DETERMINATION

System: Stormwater System

Subject: ARFF Station Consolidation

Revised Stormwater Drainage Design

EXHIBIT I – Proposed Drainage Map “West ARFF Station”

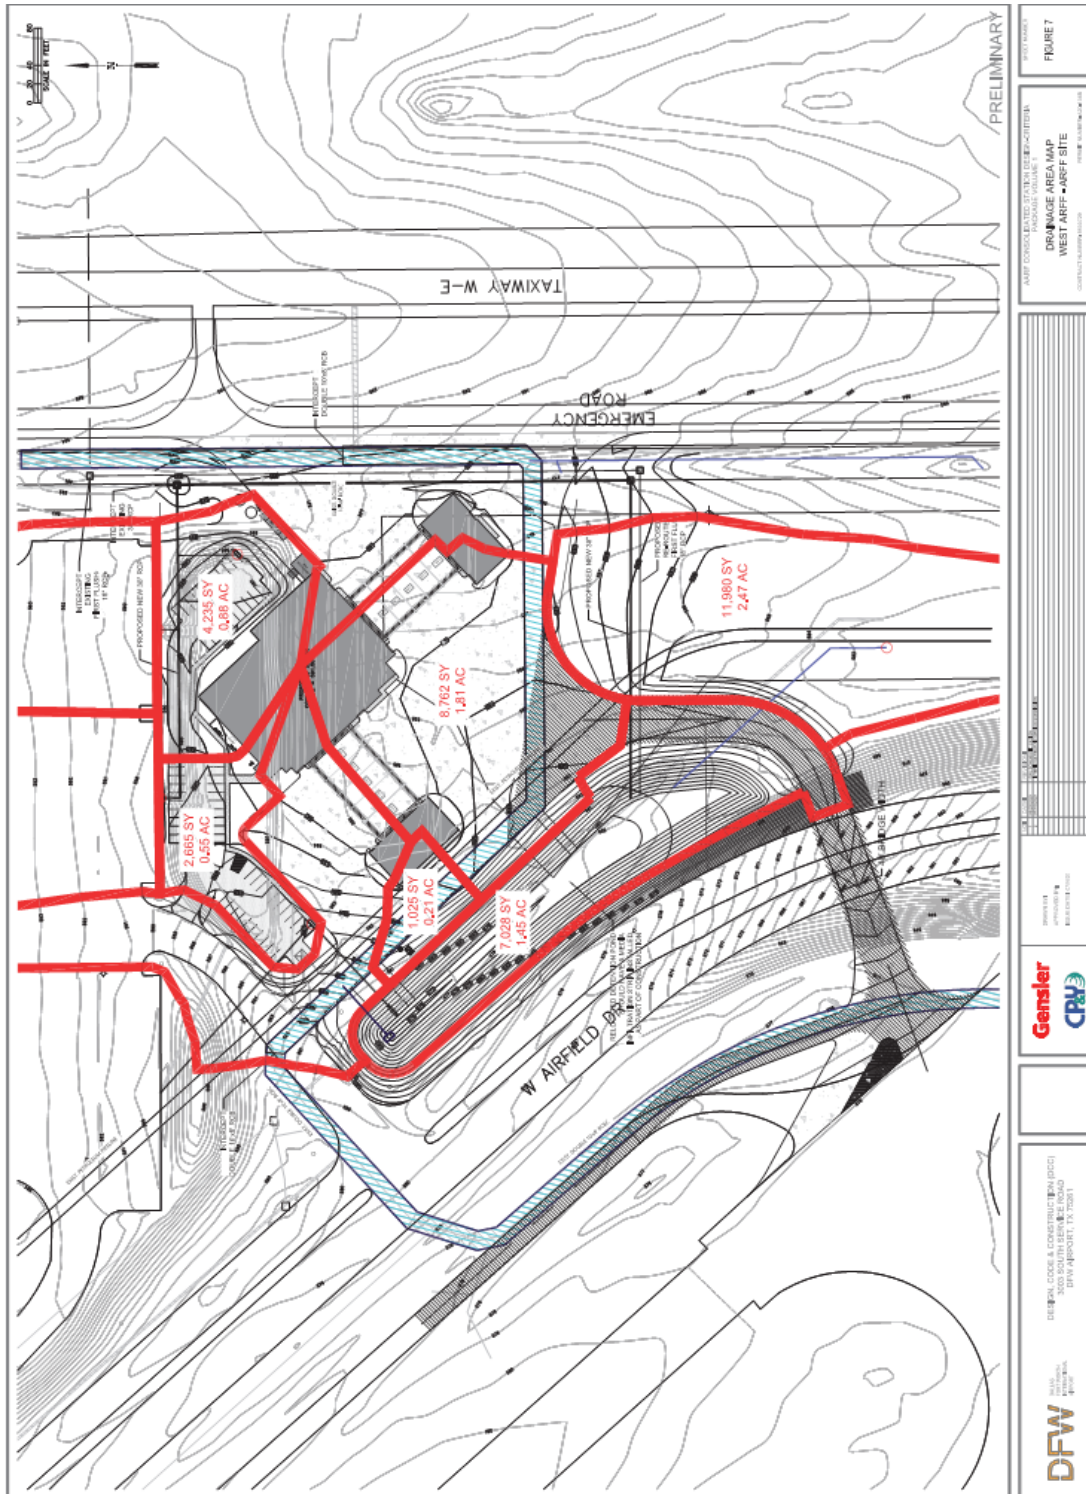
The area proposed for the new West ARFF Station has an existing dry detention pond that accepts drainage from the DFW International Air Cargo III ramp area (refer to Figure 2). This pond will be filled, and a new pond will be constructed (see Exhibit 1 – Proposed Drainage Map of West ARFF Station) to accept drainage from the DFW International Air Cargo ramp and the new West ARFF Station development. In addition, first flush drainage from Line I3 of the First Flush System (purple line in Figure 2), which collects the first flush from approximately 126 acres of impervious area from the UPS, American Airline Hangar and International Air Cargo ramps, will be diverted into this new detention pond. The final design must comply with the first flush requirement of capturing 0.25 inches of runoff from impervious areas by incorporating a pilot channel in the proposed pond with layered media that can filtrate the runoff (excluding roofs). Per Section 3 – Preliminary Data and Design Requirements of the referenced Report, the concept is to incorporate stormwater detention with filtration media.

The new Fumigation Facility detention pond, which will drain into an existing 18-Inch RCP that conveys stormwater into the West 23rd St. storm drain system, must drain within 24 hours after the peak of the 100-Year design storm event. Also, the proposed detention pond from the West ARFF Station must drain within 24 hours after the peak of the 100-Year design storm event, complying with the DFW Design Criteria Manual and Advisory Circular no. 150/5200-33C that requires water facilities to drain within 48 hours to avoid wildlife attraction.

EXHIBIT II – Proposed Drainage Map “East ARFF Station”

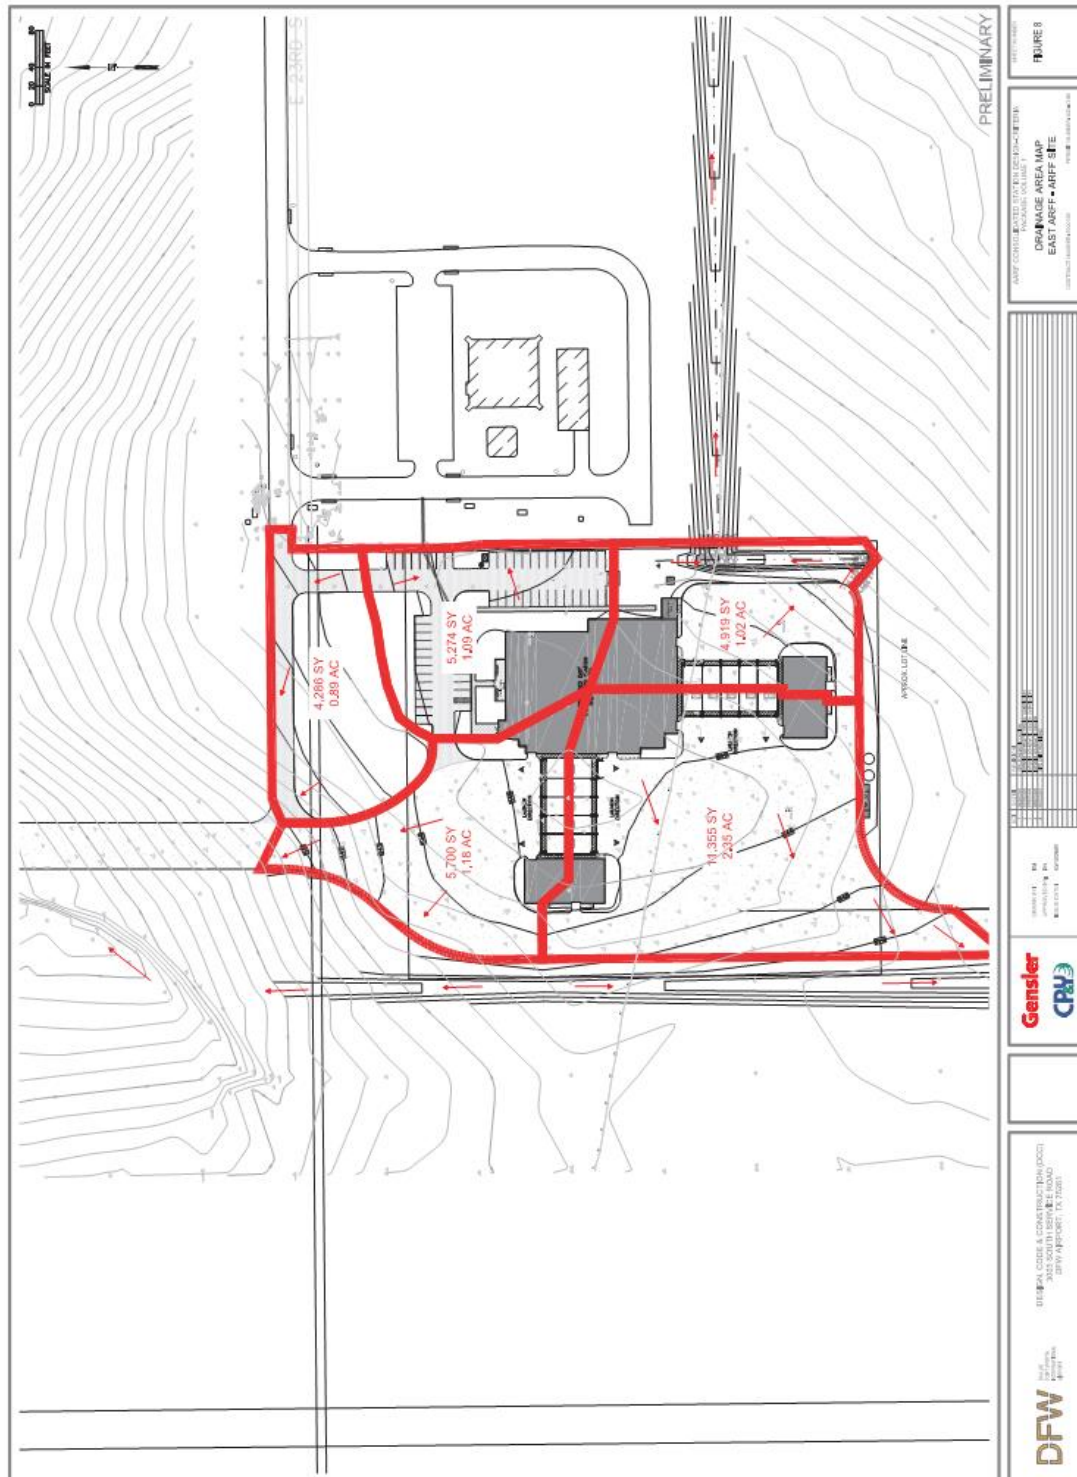
The East ARFF Station will need to be split into three (3) sub drainage areas with the north drainage area draining into Mud Springs Creek via the existing MS-D1 channel to the north of the development and south drainage areas 1) draining to the existing MS-C concrete-lined channel to the east of

the development as seen in Figure 3 and 2) sheet flowing to the southwest to a grassy open area (refer to Exhibit III). The parking area will drain into a 700-foot long vegetative swale that will drain into the MS-C concrete-lined channel. This vegetated swale will provide sufficient water treatment for the operational use of the impervious area of this development.
